**PLANNING COMMISSION SPECIAL MEETING
THURSDAY, SEPTEMBER 09, 2021**

4.a (6:45 PM) - Planning Commission Deliberation & Recommendation on Wintergreen Townhomes Subdivision, Site Plan Review and Conditional Use Permit Adjustment (PLN51836 SUB SPR CUPA)

2.a Review, Public Comment & Recommendation on Wintergreen Townhomes Subdivision, Site Plan Review and Conditional Use Permit Adjustment (PLN51836 SUB SPR CUPA)

Surface Water:

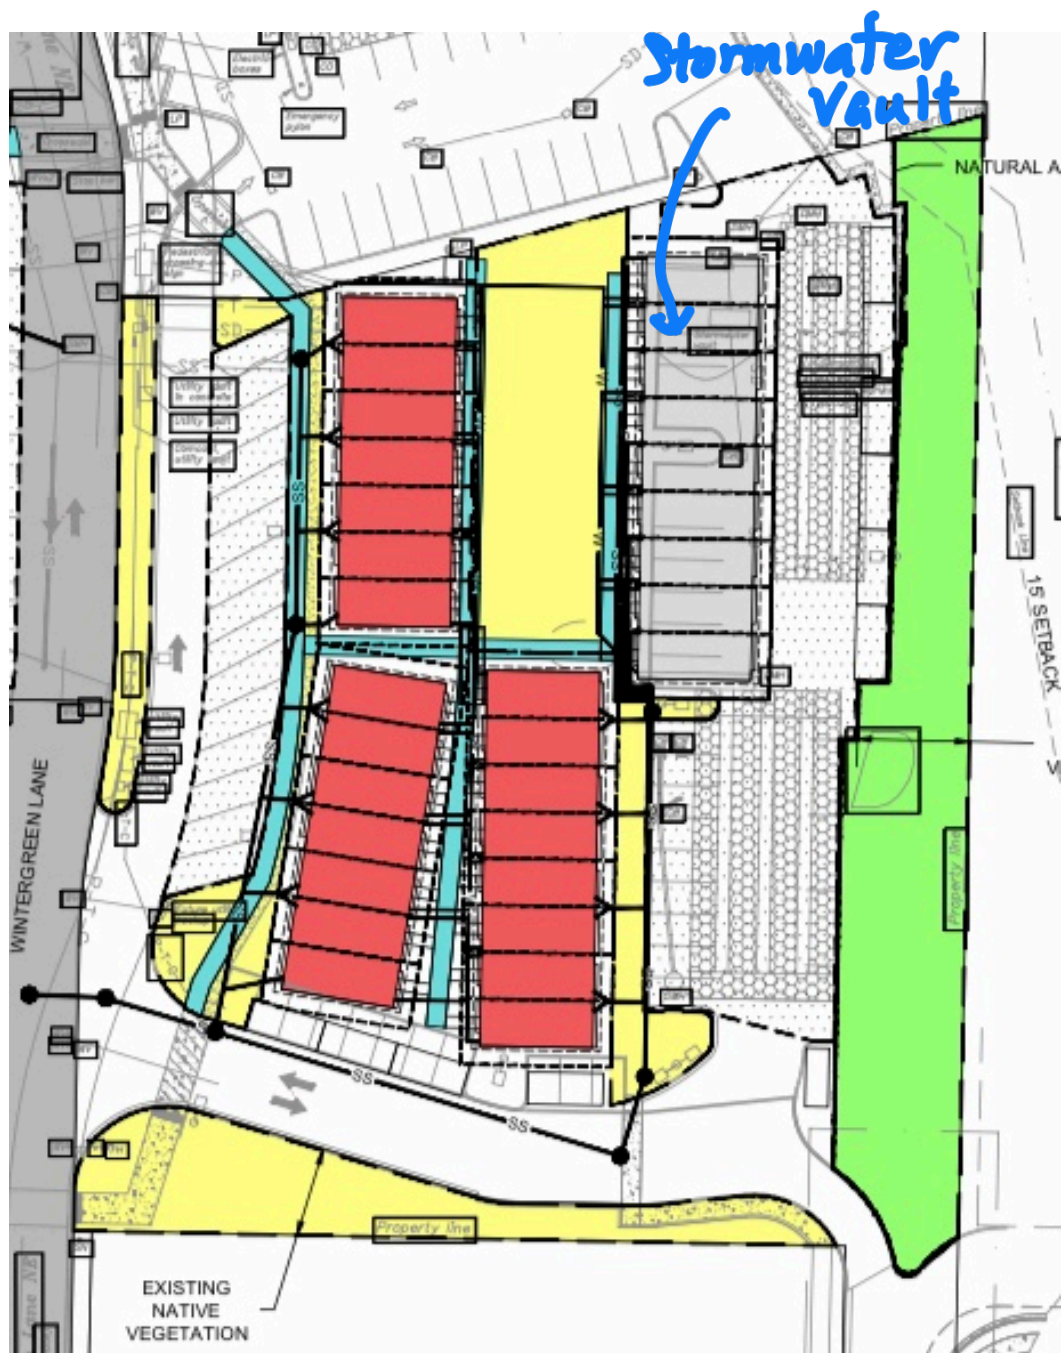
“A WETLAND IS LOCATED OFFSITE TO THE EAST WITH COBI APPROVED BUFFERS THAT DO NOT AFFECT THE TOWNHOME PROJECT’S BUILDABLE AREA ON EITHER LOT.”

Yet the builder is planning to build east of the building lot, over existing structures that protect that wetland.
